SERVICE BULLETIN

BULLETIN NUMBER: 267

SUBJECT: AC Wiring – Possible Wire Color Variation

MODEL AFFECTED: 3.0 BCG and 3.5 SBCG

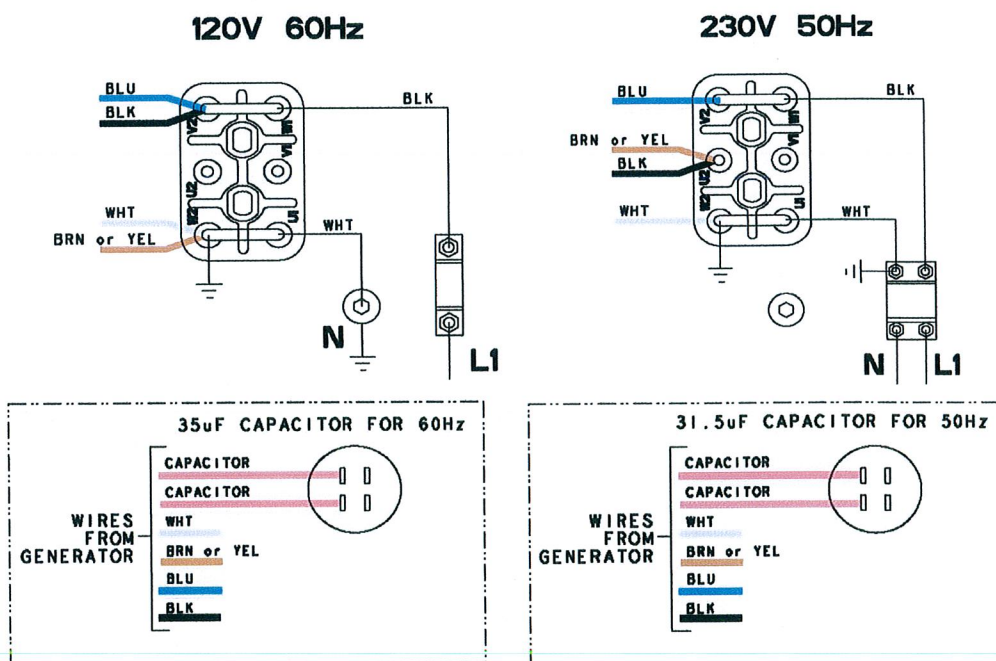
DETAIL: There is a possible variation in the color of the BROWN wire used on the AC backend for the 3.0 BCG and 3.5 SBCG gasoline gensets. The BROWN wire could be YELLOW.

This possible variation affects the 3.5 SBCG manufactured beginning March 2013 - manufacturing date code "MC". Since the 3.0 BCG was not in production during this time it will be affected only if the generator backend is replaced in the field. If the technician is replacing the backend on a 3.0 BCG, the replacement may have a BROWN or a YELLOW wire.

Refer to the diagram below and keep this bulletin in your technical documentation file for reference.
